REMARKS

VERSION WITH MARKINGS TO SHOW CHANGES MADE

FIG. 1A

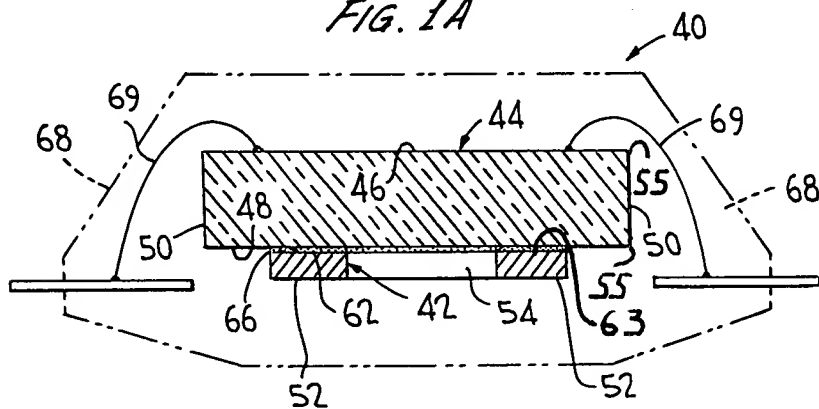
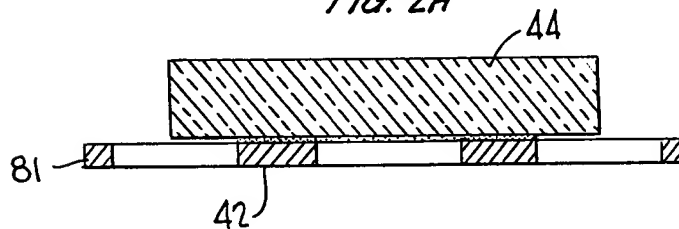
The drawings are objected to because "references signs 55, 63 and 88 are not shown." Applicants file herewith a separate Request for Approval of Drawing Corrections which includes amendments to Fig. 1A. Applicants respectfully traverse this objection with respect to reference sign 88.

FIG. 6A PRIOR ART

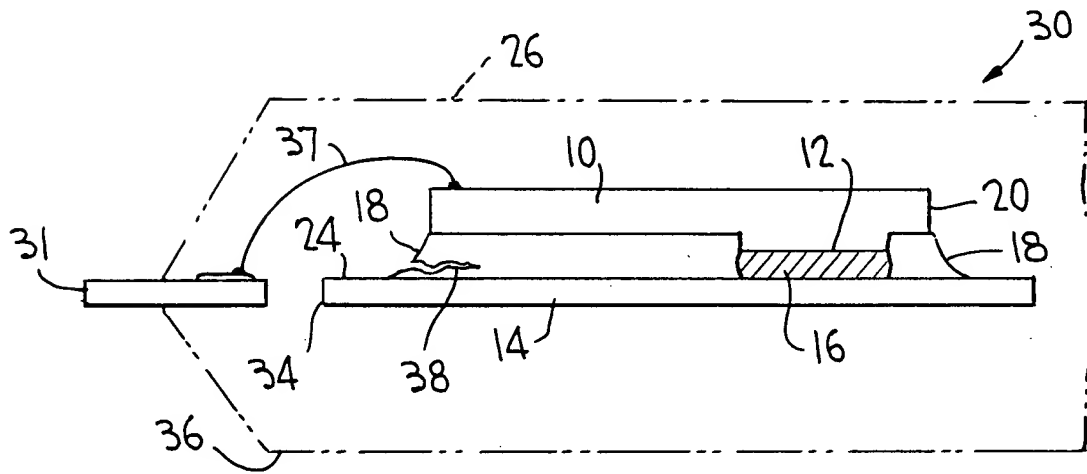
Figs. 6, 6A and 6B are objected to because "they should be designated by a legend such as --Prior Art--." Applicants file herewith a separate Request for Approval of Drawing Corrections which includes amendments to Figs. 6, 6A and 6B.

PRIOR ART
